Access Compliance Report Public Rights-of-Way (Island Curb Cuts)

Main Street: SIENNA_PKWY		Cross Street: SIENNA_PKWY		Location:	NE
ADA ID: CCRK211111130501	Curb Cut Type: MedianRefuge2	Initial Pass/Fail: Pass	Overall Compliance: No	Severity Score:	7.5
Codes/Mitigation Info/Possible Solution			Field Measurements/Component Compliance

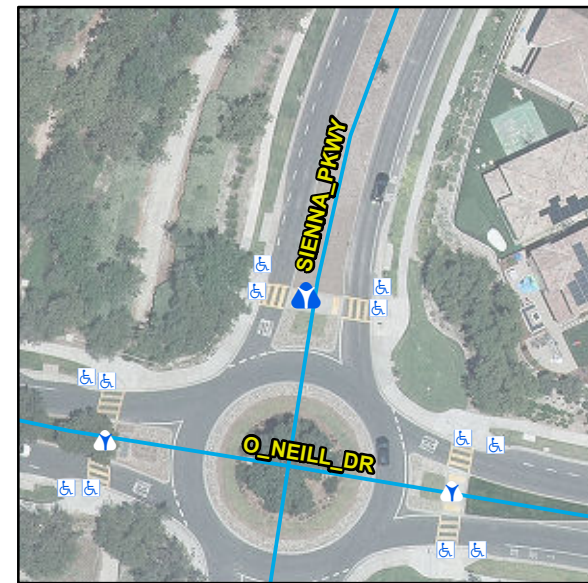
Yes	Refuge Inside Cross Walk 2	Yes	No	DWS 2 Full Width	No
	Road 2 Slope (%)	2.1	No	DWS 2 Offset (In)	38
	Road 2 Cross Slope (%)	2			
Yes	Overall Surface Condition:	Acceptable

Remove & Replace Detectable Warning System.
